Modification Recommended Service Note

N8957A - Autoranging System DC Power Supply, 1500V, 30A, 15000W, 400 VAC

Serial Numbers: DE14290000 - DE15369999 without manufacturing ID Version "B"

5) SMT resistors R93/94 are located in red circle shown below:

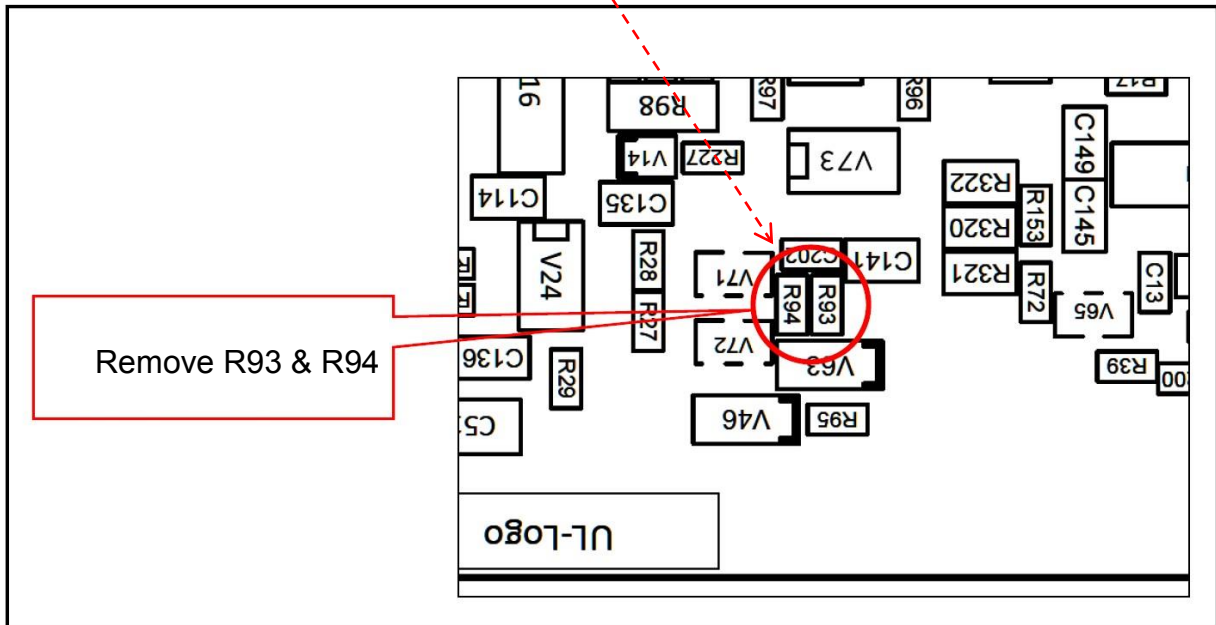
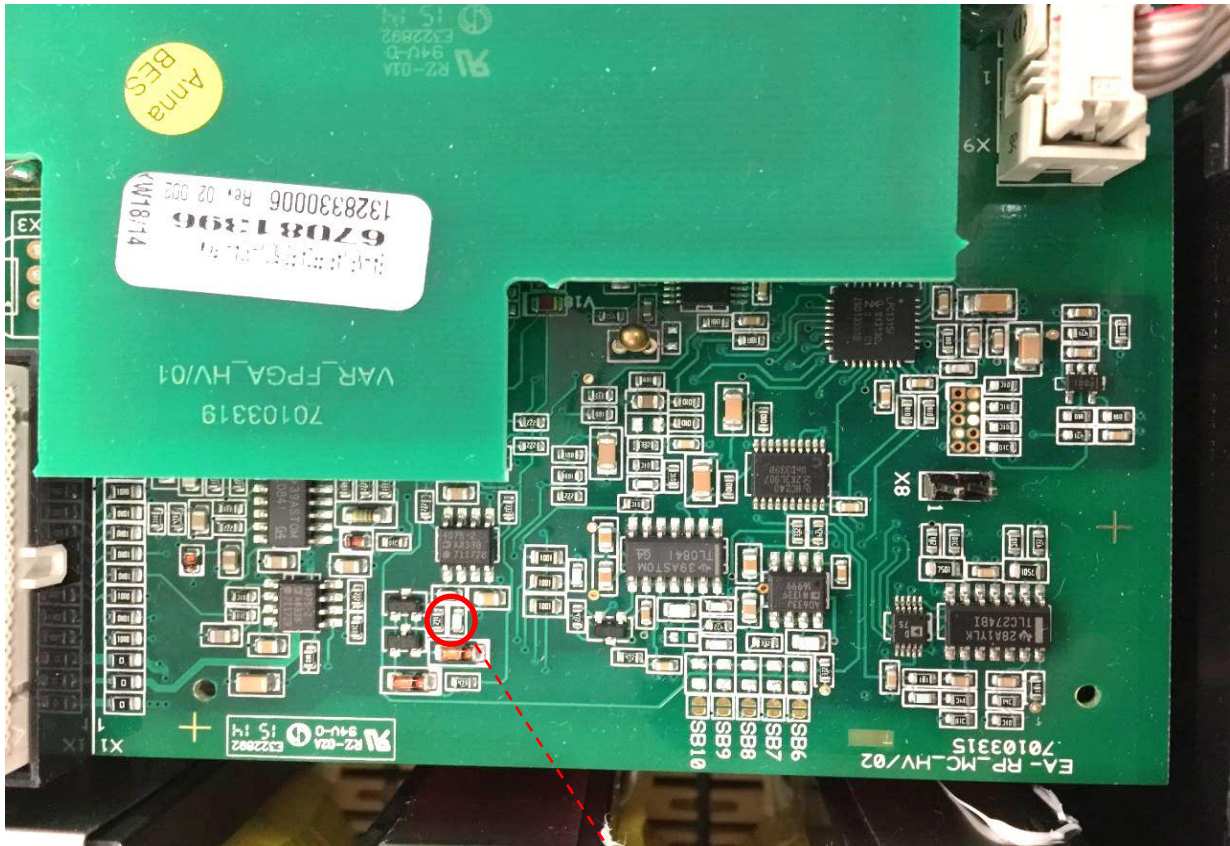
Resistors R93 and R94 must be removed, no replacement parts are required for modification.

Removal of two (2) surface mount resistors, R93 and R94, will correct this problem:

6) After removal of R93 & R94, re-install all covers. Instrument does NOT require recalibration after the removal of R93 & R94.

Suffix “B” added

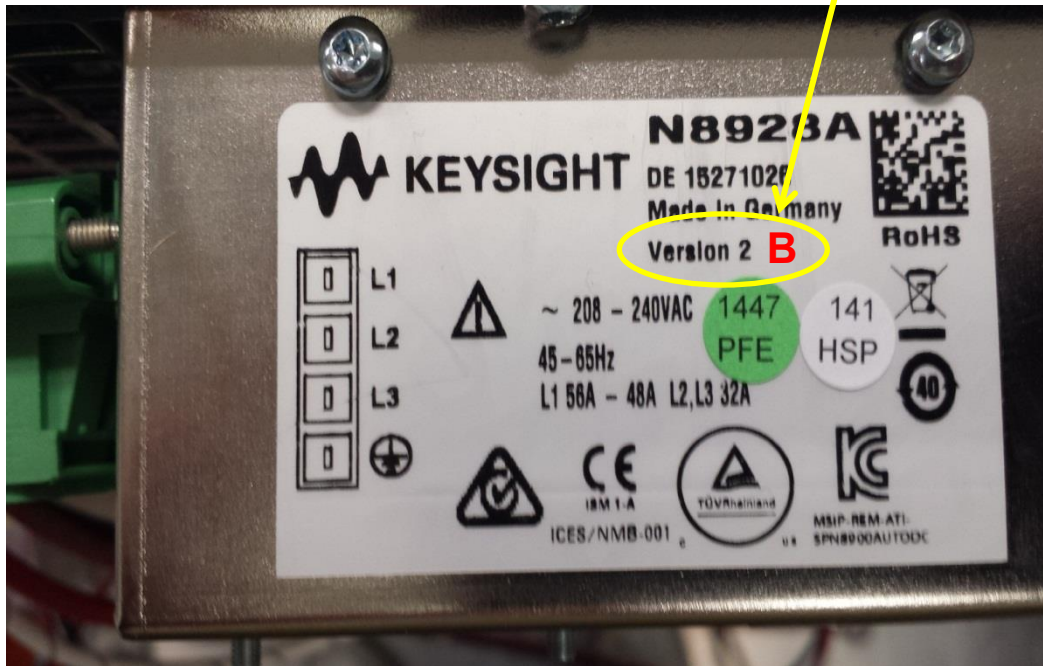
7) On the acMains label, on the rear of the instrument; use an indelible marker, to add the suffix letter “B” after the Version ID. This will assist in the tracking of modified instruments.
